Appl. No. : **10/770,884**
Filed : **February 2, 2004**

16. AMENDMENTS TO THE DRAWINGS

REMARKS

FIGURE 2

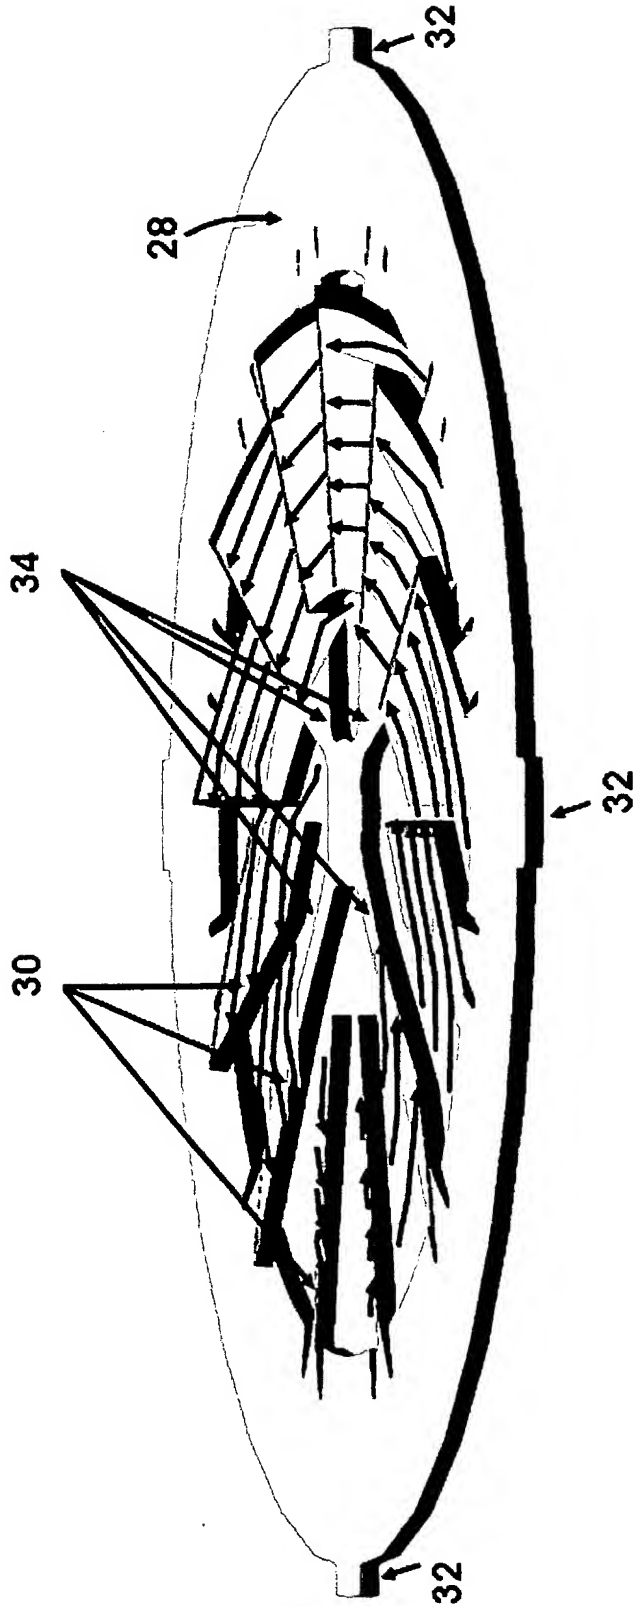
The drawings of Figure 2 have been corrected to refer to "heat reactor housing."

Corrections include:

Text (Combustion Chamber) has been changed to read (Heat Reactor Housing)

Figure 4

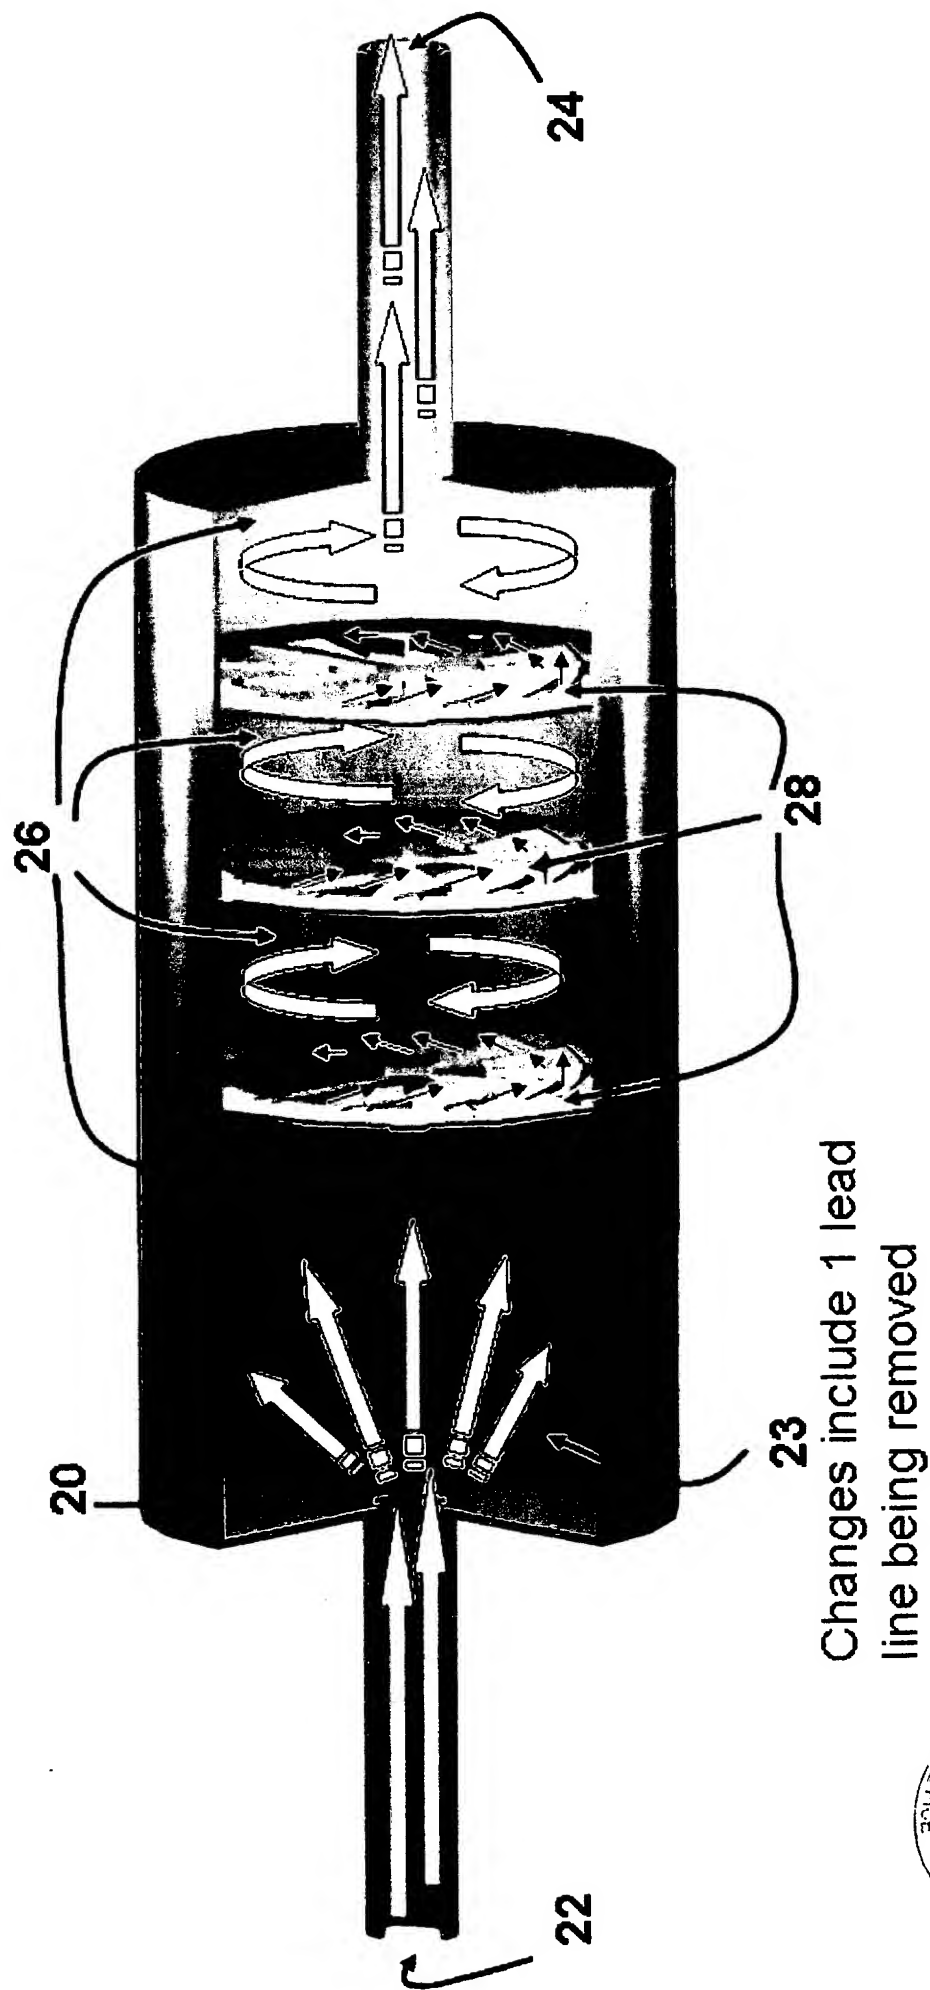
Changes include corrected margins and
deletion of arrows indicating flow
